Re: Negative Declaration for a rock revetment at the Kahana
Outrigger Condominium, TMK: 4-3-5:20, 21, & 31, Lahaina,
Maui.

1994-09-23-MA-~~FEA~~ Kahana Outrigger Condominiums
Rock Wall Revetment

MAUI PLANNING DEPARTMENT'S REPORT
for the
Maui Planning Commission Meeting on
July 12, 1994

PROJECT No.	K 203101
PROJECT	ROCK RETAINMENT, KAHANA CURRIGGER
LOCATION	KAHANA, MAUI
SPK-ROBINSON INC.	
DATE	JAN 11, 14
SITE PLAN	
DRAWN BY	W
FIGURE No.	01

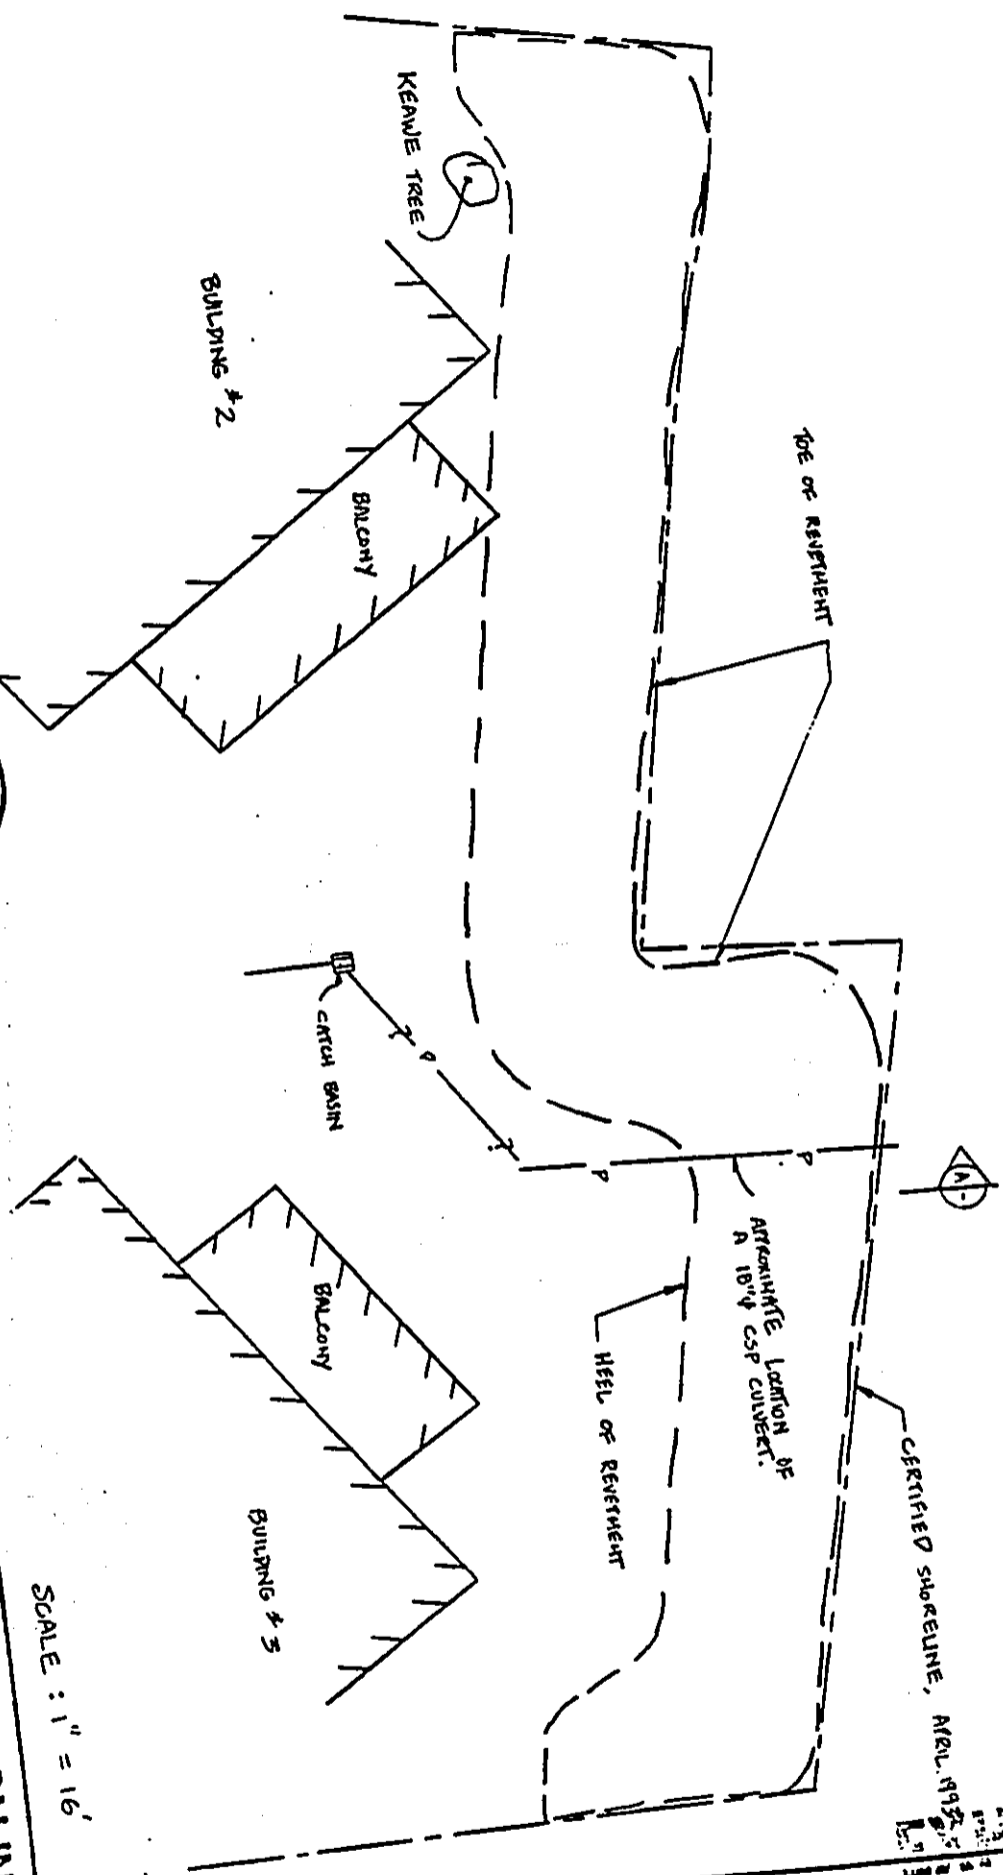
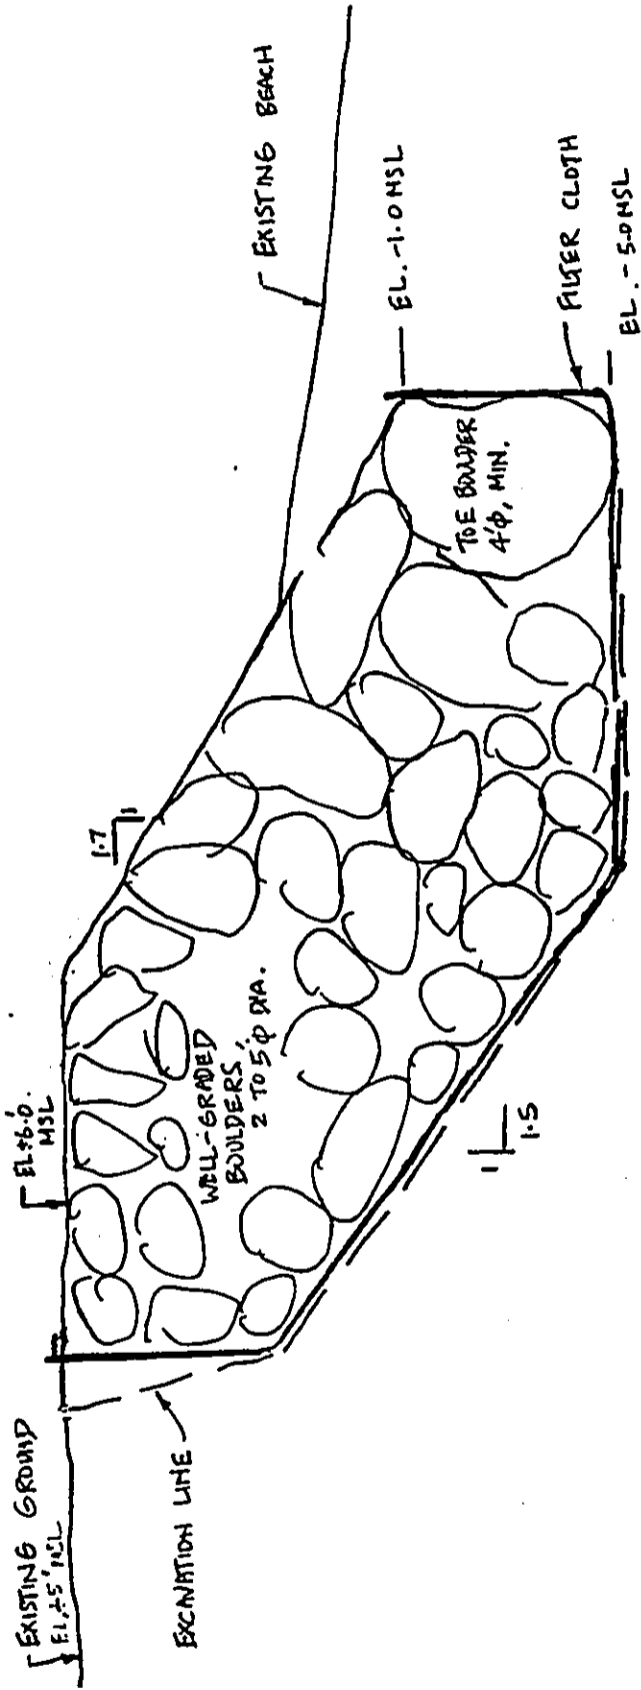
a) The certified shoreline date be verified. The report and construction plan dates differ with April 1990 and April 1993, respectively. We request that the plans be resubmitted for review with an updated shoreline map if the current plans are based on a certified shoreline of April 1990.

b) The steep slope of the revetment and the close proximity of the cap wall to the shoreline may affect the accumulation of sand along the beach. We do not expect guarantees for sand accumulation but do expect assurances that the proposed design enhances beach sand build-up.

c) The design considerations for the rock dimensions and weights should be provided for review.

1. Based on past experience and published reports, it is highly likely that an ocean rock revetment with a steep face slope of 2:1 will have an adverse effect on adjacent properties as well as the inshore environment.
2. The proposed design wave height of 5 feet may be too small. (I used a 6-foot design wave for the design of the Mahana Condominium seawall revetment -- a figure given to me by Ocean Engineering, Inc., a coastal engineering firm on Oahu.)
3. The location of the wall needs to be carefully considered. I would recommend a "split pitch" wall with face slopes of 5:1 horizontal:vertical) and an upper wall width of 3:1 or 2:1 slope. If the Certified Shoreline limits the placement of such a split pitch wall, then either:
